Access Compliance Report Public Rights-of-Way (Curb Ramps)

Main Street: CREIGHTON_DR Cross Street: UNIVERSITY_AVE Location: N

ADA ID: RPRK211026140430 Ramp Type: Type 4 - Parallel Initial Pass/Fail: Fail Overall Compliance: No Severity Score: 2

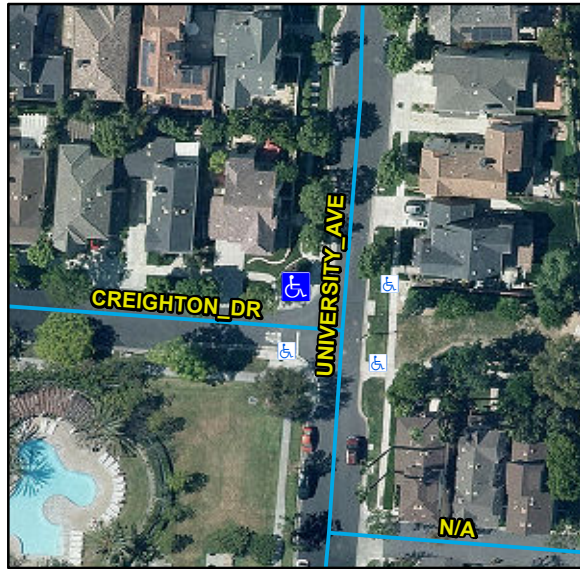
Compliance	Description	Data	Compliance	Description	Data
N/A	Ramp Length LT (in)	130	N/A	Ramp Length RT (in)	130
Yes	Ramp Width LT (in)	91	Yes	Ramp Width RT (in)	87
Yes	Ramp Run Slope LT (%)	6.2	Yes	Ramp Run Slope RT (%)	4.5
No	Ramp Cross Slope LT (%)	3.2	No	Ramp Cross Slope RT (%)	2.3
N/A	Landing Present	N/A	N/A	DWS Provided	N/A
N/A	Landing Length (in)	N/A	N/A	DWS Contrast	N/A
N/A	Landing Width (in)	N/A	N/A	DWS Length (in)	N/A
N/A	Landing Run Slope (%)	N/A	N/A	DWS Full Width	N/A
N/A	Landing Cross Slope (%)	N/A		DWS Offset Type	N/A
N/A	Landing Movement Obstructed?	N/A	N/A	DWS Offset Left (in)	N/A
	Landing Movement Type	N/A	N/A	DWS Offset Right (in)	N/A
N/A	Landing Shared	N/A			
N/A	Clear Space	Yes			
N/A	Clear Space To Crosswalk (in)	N/A			
N/A	Marked Crosswalk 1	No	N/A	Marked Crosswalk 2	No
	Crossing 1 Direction	SW		Crossing 2 Direction	SE
	Marked Crosswalk 1 Width (in)	N/A		Marked Crosswalk 2 Width (in)	N/A

Remove & Replace Curb Ramp With Two New Directional Ramps or Equivalent.
